Change Order #5

Las Milpas Road

Owner: Hidalgo County Precinct #2
To: GO Underground, LLC
217 E. Monroe Ave.
Harlingen Texas 78550-5519
From: B2Z Engineering
Project: Las Milpas Road
Contract: C-22-0094-09-06(ARPA 22-1-122-109)
Limits: McColl Rd (FM 3062) to 10th Street (FM 336)

Subject: Change Order #5 in the amount of \$557,423.18 has been approved by Hidalgo County Precinct #2 to make the following changes.

LAS MILPAS ROAD TUNNEL LAYOUT (CROSS SECTION)
 EDWINA COMPTON
 ENGINEER
 ILLINOIS
 No. 107682
 11/28/2023

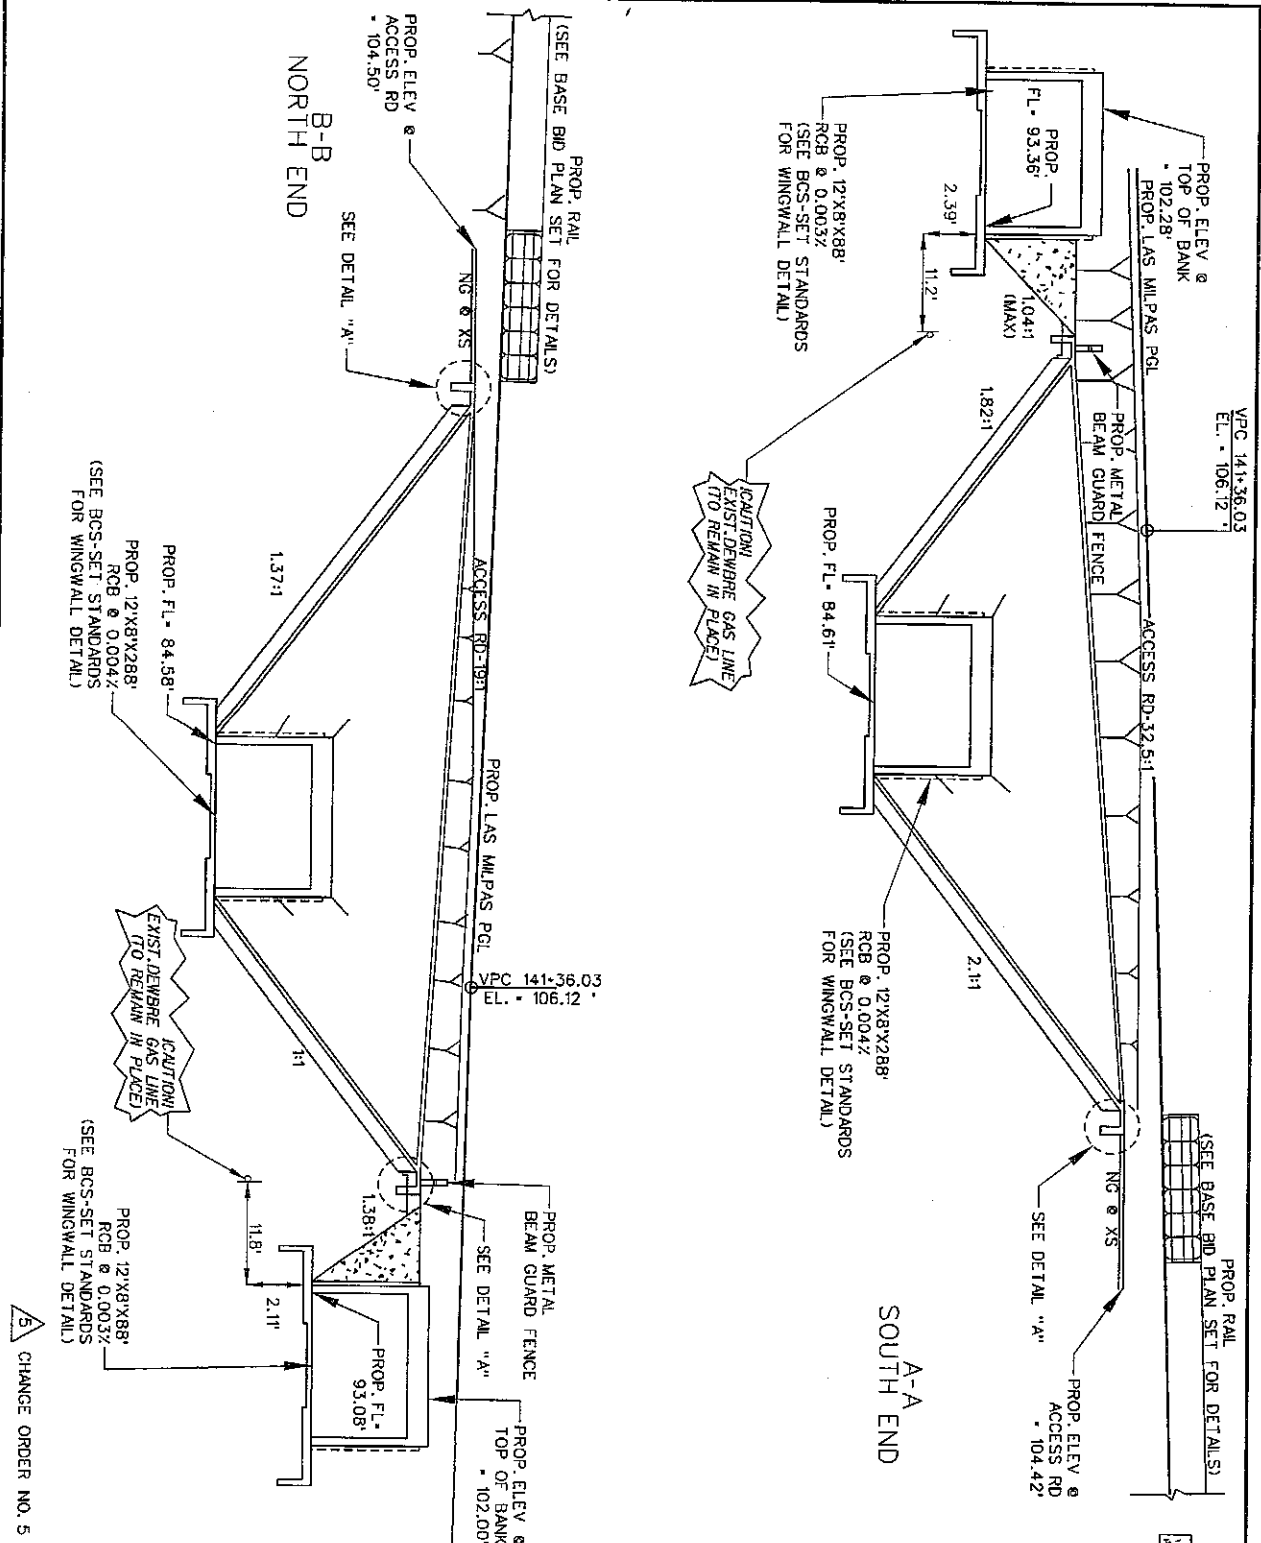
Description: Change Order No. 5 (CO#5) introduces plans and quantities to construct a new 12'W x 8'H x 88' long drainage structure underneath Las Milpas Road. It is designed as an overflow drainage structure to be used as an equalizer during heavy rain events on the west side of the Main Canal. During inclement weather the ditch waters build up, rise, and overflow the bank into farmers' fields. The new structure will serve as an equalizer for the bridge to allow water to cross underneath the road without overflowing the outer banks and spilling over into farmed fields. CO#5 introduces new items, quantities and prices and uses existing items for additional quantities into the contract to provides additional drainage during heavy rain events.

CO#5 adds a new drainage culvert that crosses under the Las Milpas Road for the ditch overflow that impacts farmed fields during heavy rains. It is a 12' x8' single box culvert that includes wingwalls, structl excav, riprap, 18" RCP, SET's & MBGF. CO#5 adds quantity to exiting items and introduces new items and prices. The Las Milpas Rd is currently under construction and a quick approval of CO#5 is required to not delay the project. CO#5 adds 100 days and 5 months of barricades to complete.
